# CITY OF ALBUQUERQUE

Re: **ot 28 A o Inte tate In t a T act** Lot 28-A of Interstate Industrial Tract  
**E on St. NE** 4000 Ellison St. NE  
**T a c C c at on a o t** Traffic Circulation Layout  
Architect's Stamp 5-9-22 (D17-D074)

The TCL submittal received 05-09-2022 is approved for Building Permit. A copy of the stamped and signed plan will be needed for each of the building permit plans. Please keep the original to be used for certification of the site for final C.O. for Transportation.

TRAFFIC 1

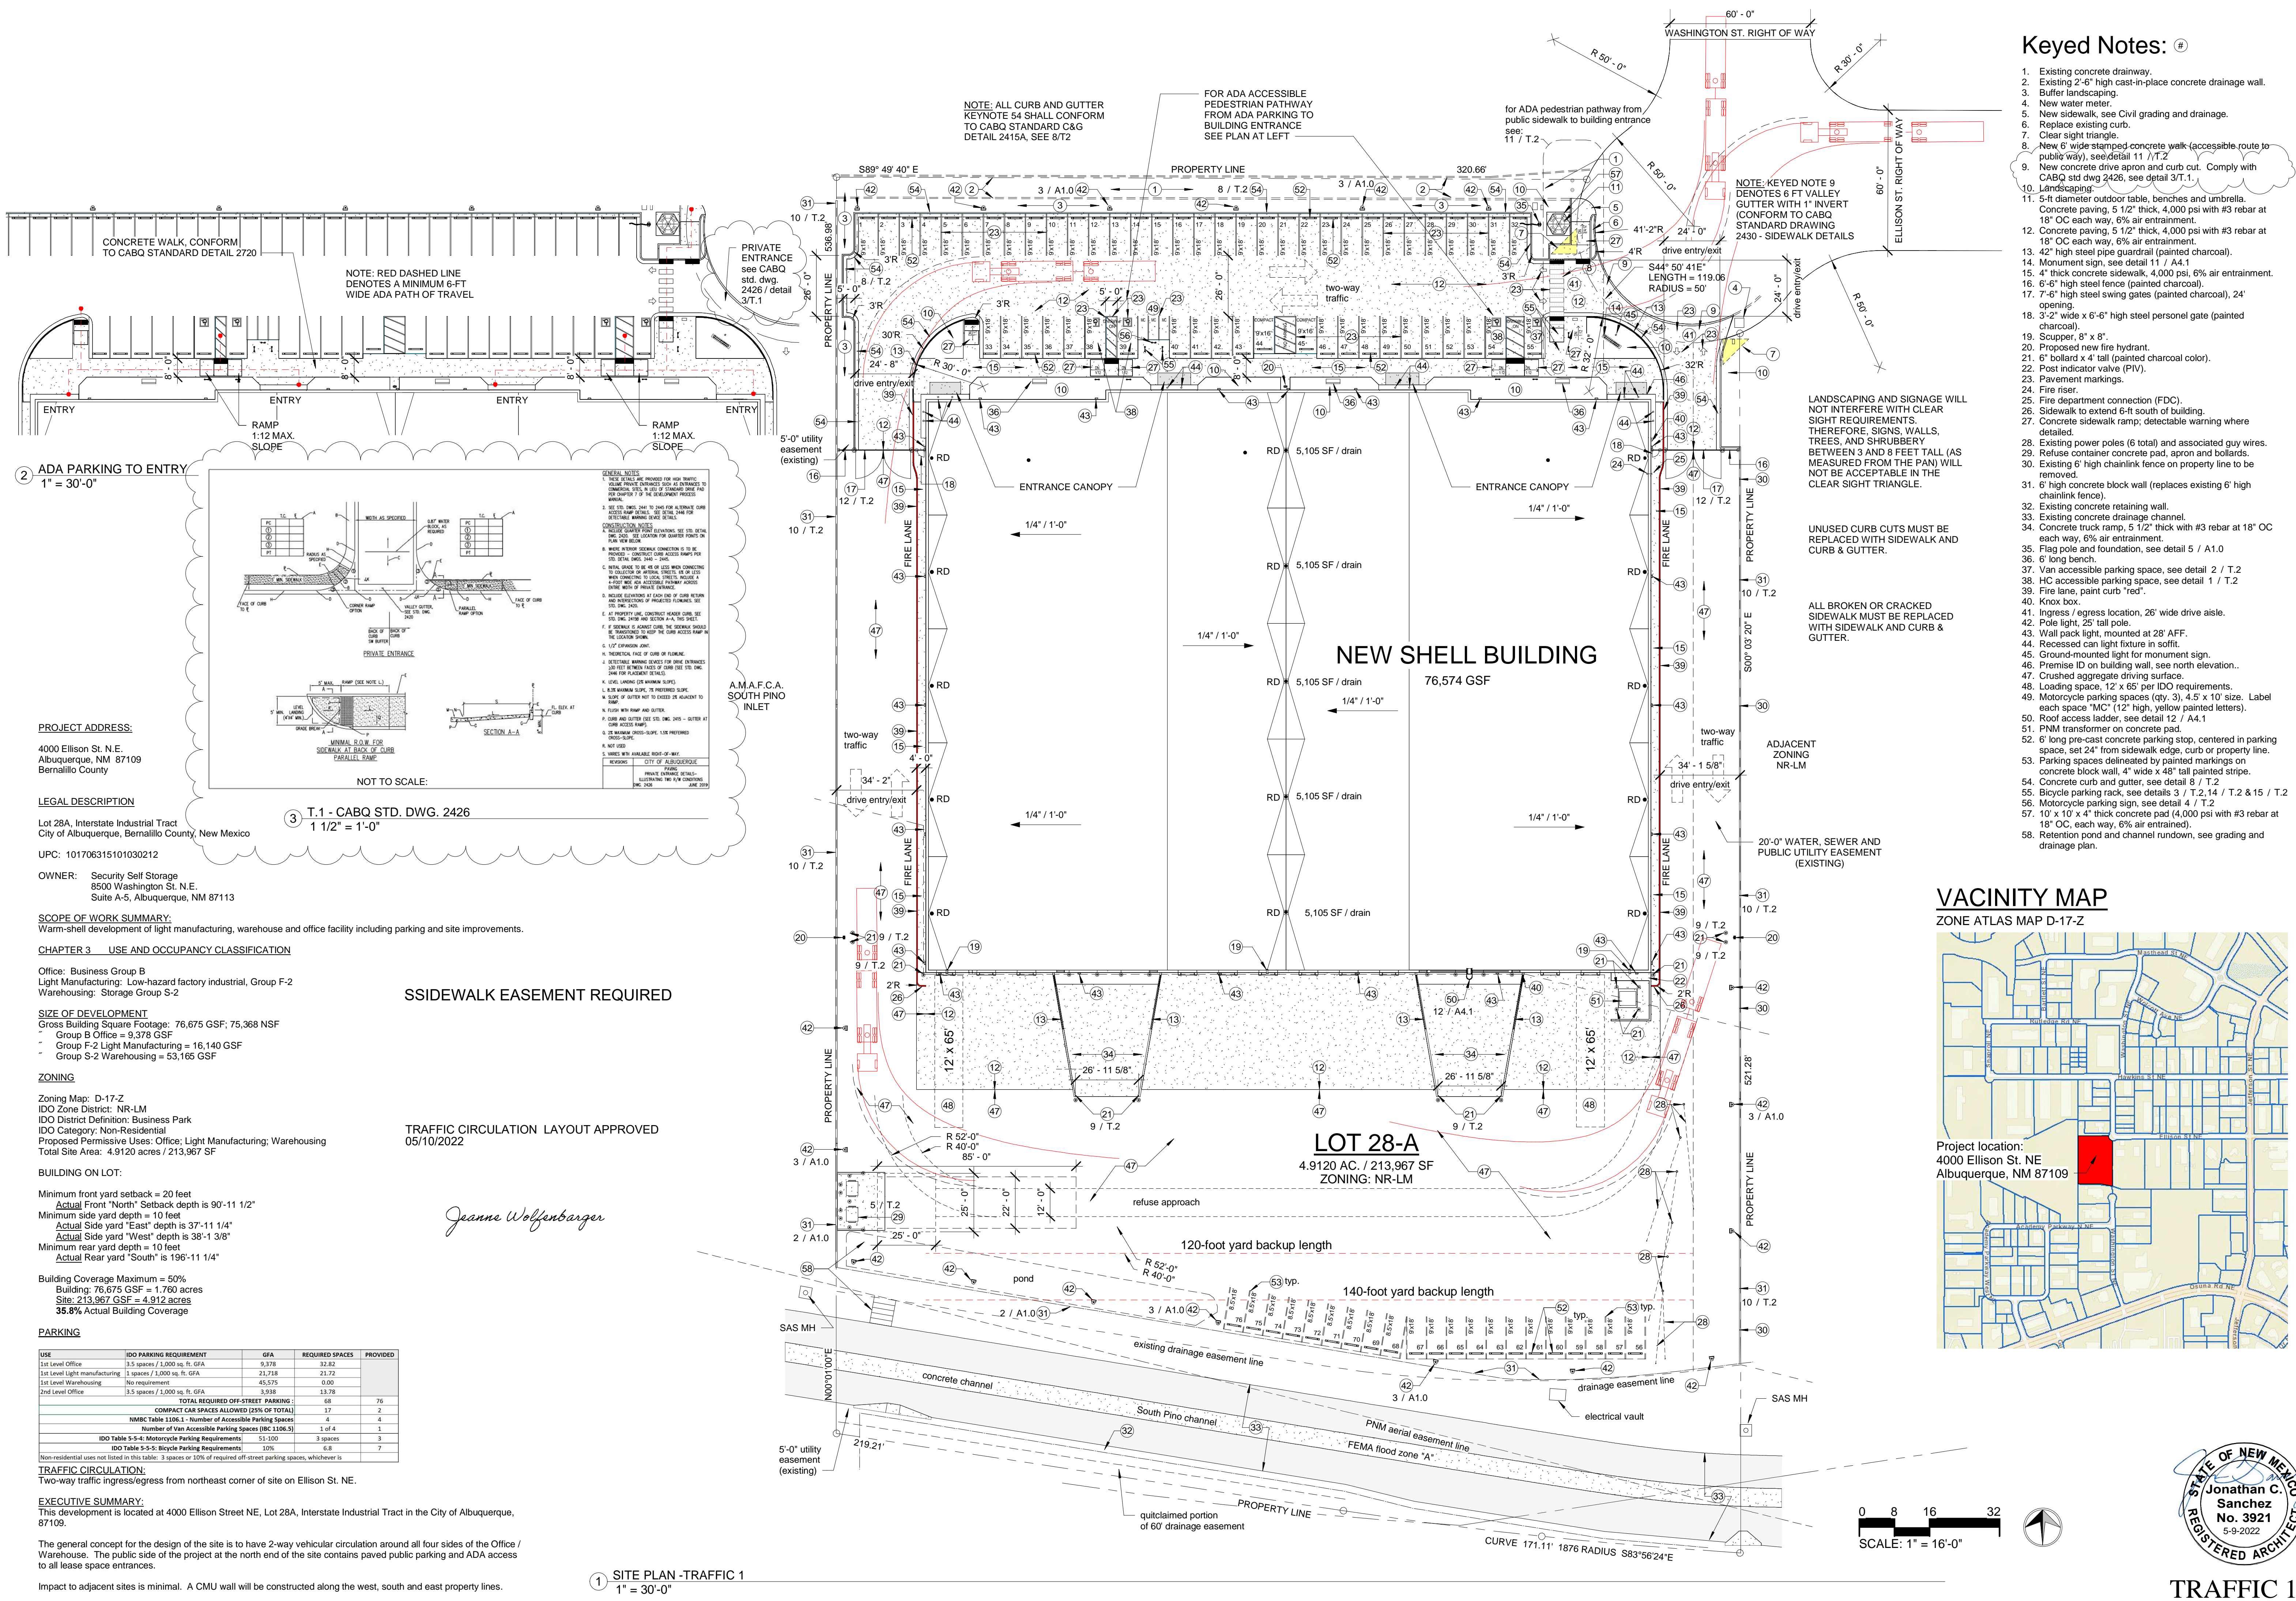
When the site construction is completed and an inspection for Certificate of Occupancy (C.O.) is requested, use the original City stamped approved TCL for certification. Redline any minor changes and adjustments that were made in the field. A NM registered architect or engineer must stamp, sign, and date the certification TCL along with indicating that the development was built in "substantial compliance" with the TCL. Submit this certification, the TCL, and a completed Drainage and Transportation Information Sheet to front counter personnel for log in and evaluation by Transportation. ***A sidewalk easement will be needed prior to Certificate of Occupancy to incorporate the ADA pathway with a maximum 2% cross-slope along frontage of property.***
